Bus Bars problems since beginning of production of cold masses at Ansaldo Superconduttori

List of non conformities opened by Ansaldo Superconduttori:

NCR177

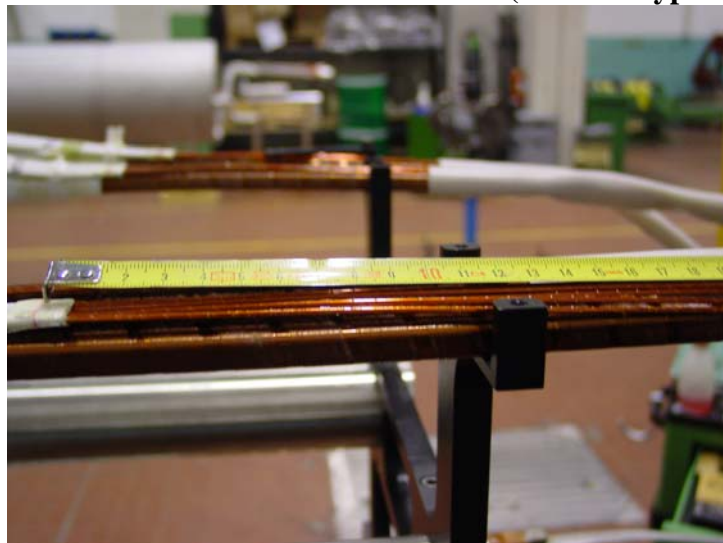
Description: With reference to dwg. nr. LHCCCHA0001-0002-0003-0004 (all rev, index D), the length of the glass cloth of auxiliary bus bars is too short (about 120mm) on both sides.

The end taping is in the position where the clamps (DWG,nr. LHCMB_E0057 & 0058) have to be mounted.

The glass epoxy plate 12x15x2.2mm (dwg. nr. LHCCCHA0003 pos.6) is missing.

NCR267

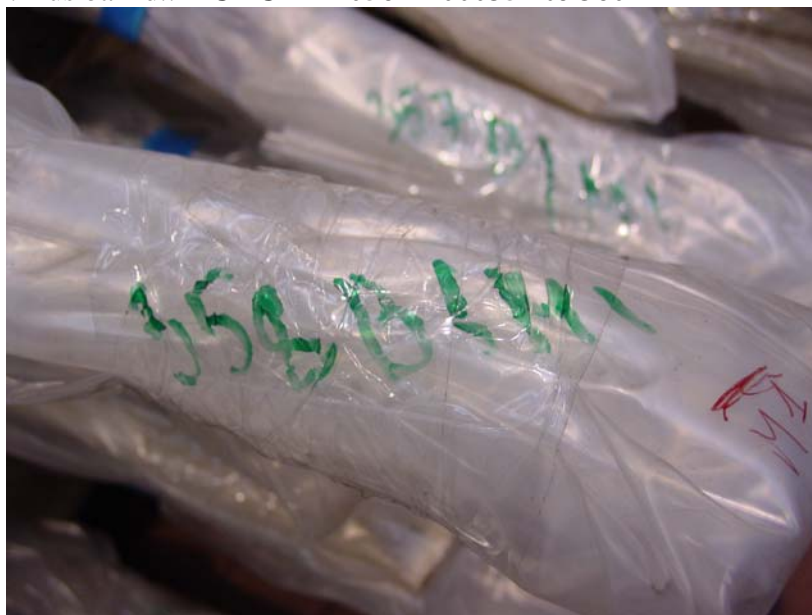
Description: During electrical check of bus-bar nr. B-360 (id. nr. HCDCBHA056-BI000360) just before longitudinal welding of CM 2137, a low insulation resistance has been found. Cause of this problem seems to be high humidity / water, get during transport of bus-bars. Same problem we found on bus bars regarding set nr. from A-336 to A-345 and from B-351 to B-360 (ref. to NC CERN 268)
